## Errata OVI40 UI V1.8 Batch 1 Kit

## Möglicher Kurzschluß (photo DF9EH)

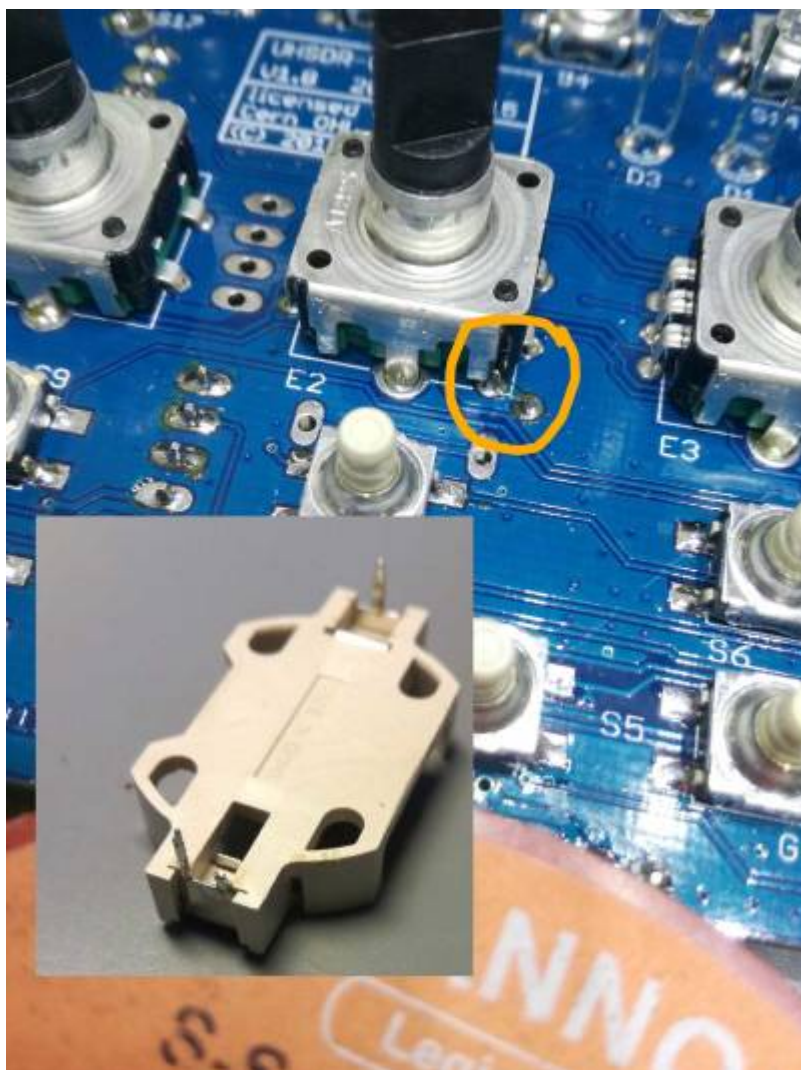
- Mini-USB socket J11 is "Type A" - this is wrong. "Type B" is mandatory to be used. Please get the correct part, e.g. Buerklin.de order number 72F2280
- The CR2032 back-up battery holder needs to be modified before soldering it in. On pin needs to be shortened so it is flush with the PCB surface TOP layer, see photo
